# PUYALLUP AOB

NE 1/4 OF THE SE 1/4 SECTION 28, TOWNSHIP 20N, RANGE 4 E  
Puyallup, Washington

**COVER SHEET**

DRAWING NO.  
 05 OF 30  
**HC-01**

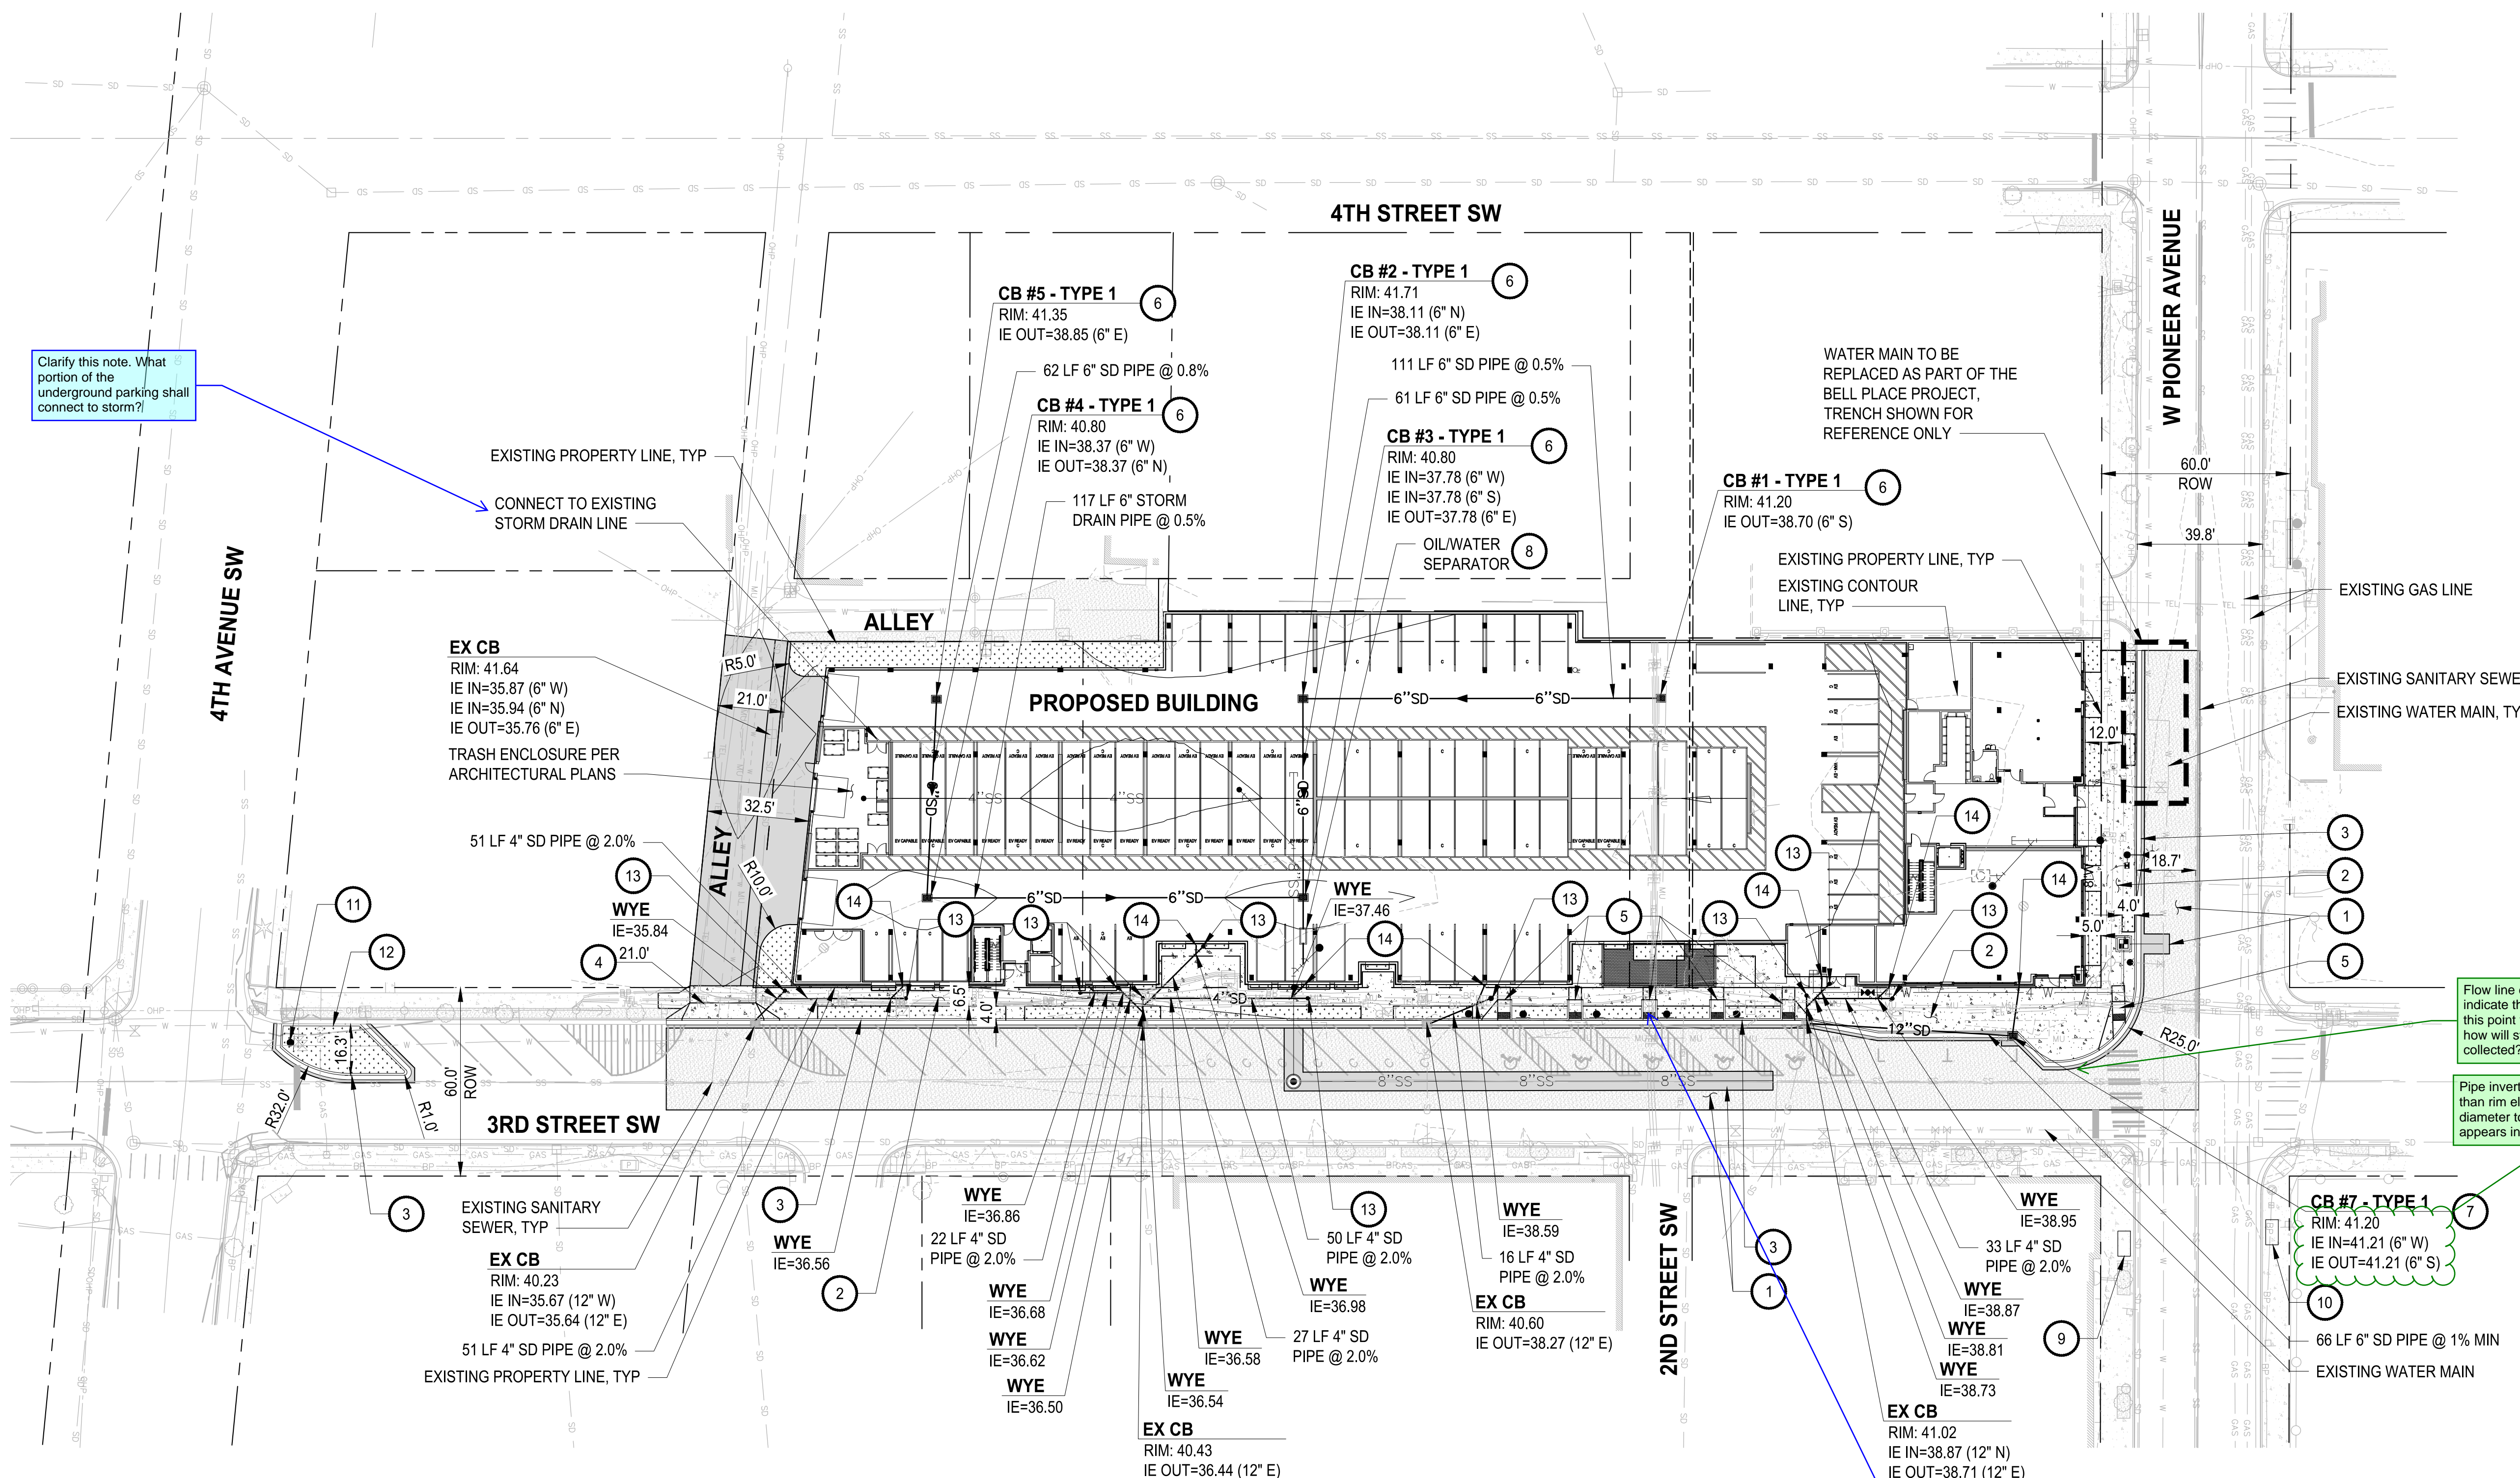
Clarify this note. What portion of the underground parking shall connect to storm?

These telecommunication manhole lids located in the existing vehicle ramp actually have about 2 feet of concrete in between them. It seems infeasible to install a new 4 foot wide ramp over them. The current shown design would have a Detectable Warning Surface directly on top of one of the manhole lids. Revise the existing layout to show the correct locations of existing infrastructure and revise the design to maintain constructability, access and utility preservation. To that end, Standard Plan M-17.10-02 shows a continuous sidewalk ramp when there are 5 accessible stalls. This would make the installation more closely resemble the existing. While having lids in ramps is never ideal, a long continuous ramp as shown in the detail would be less likely to fail.

DRAWING NO.  
 09 OF 30  
**GR-01**

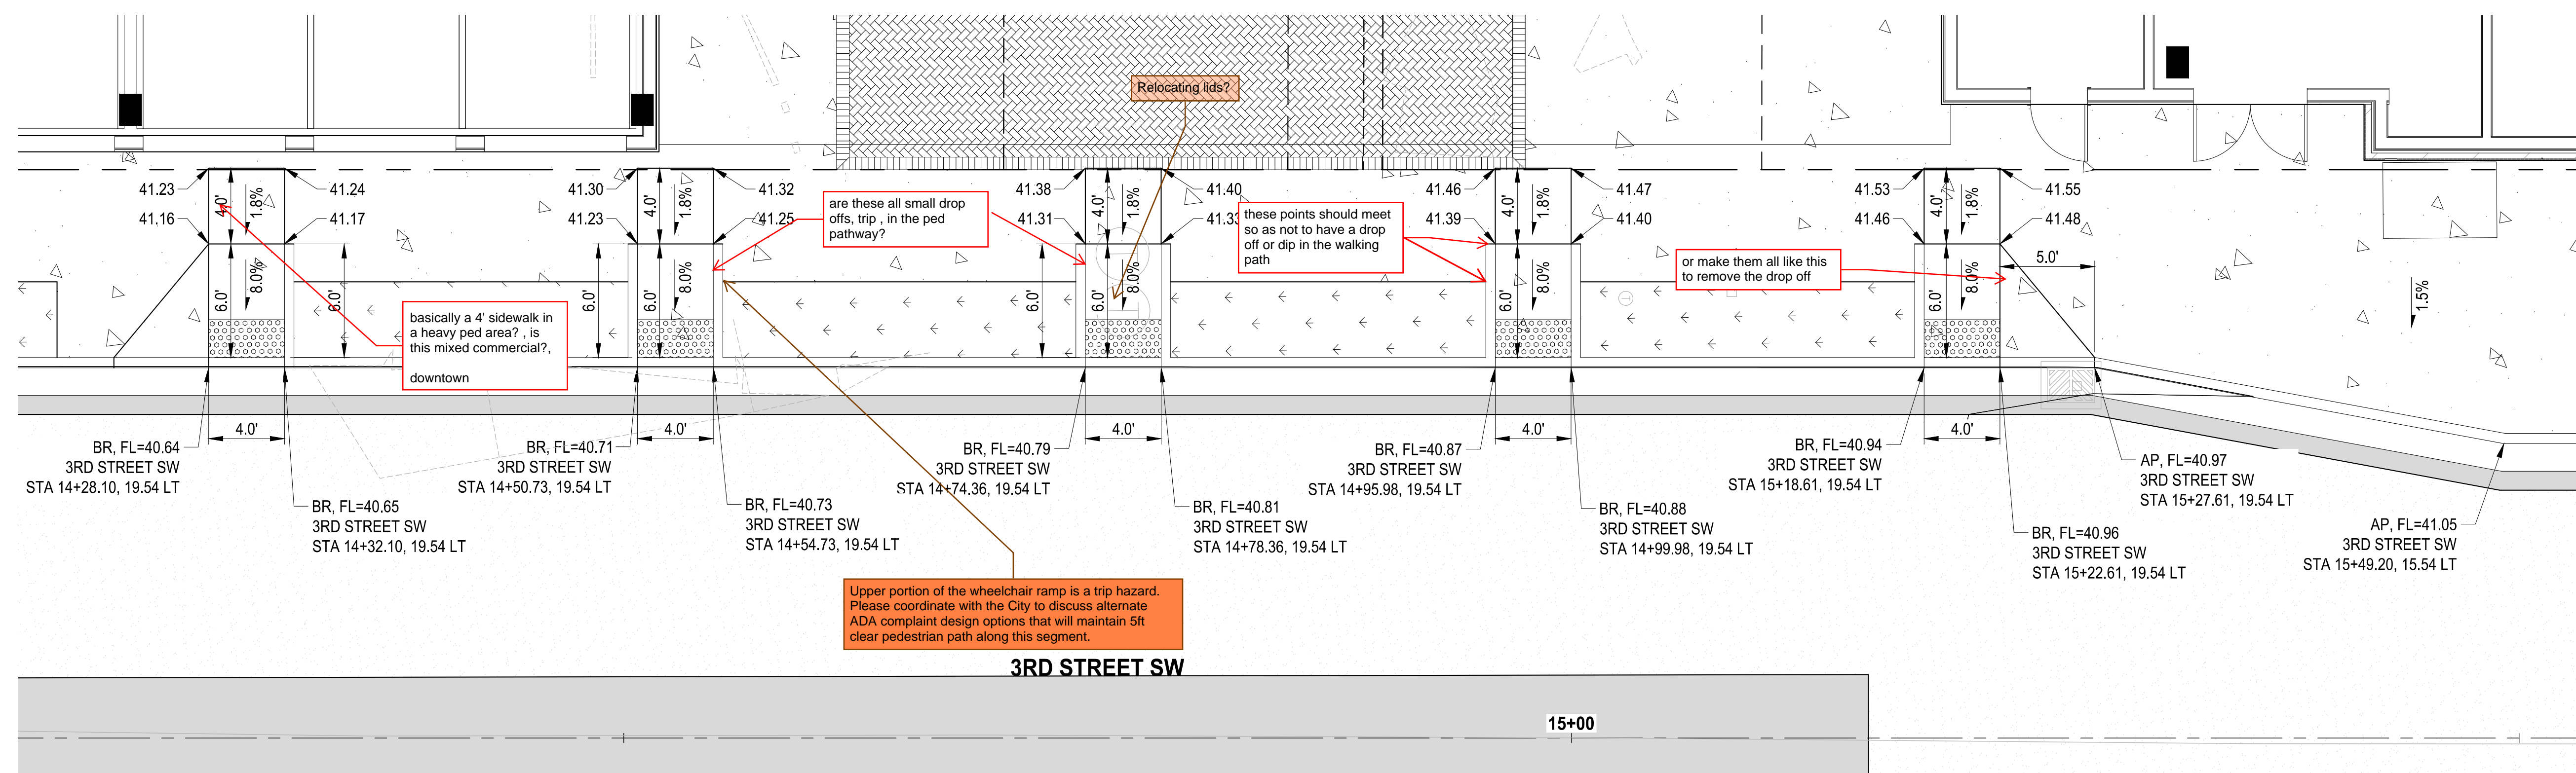
21ft is very narrow to serve this site. Per PSP comments, City would prefer this access is larger to safely accommodate simultaneous ingress/egress. The scope of this modification can be determined during Civil permit review.
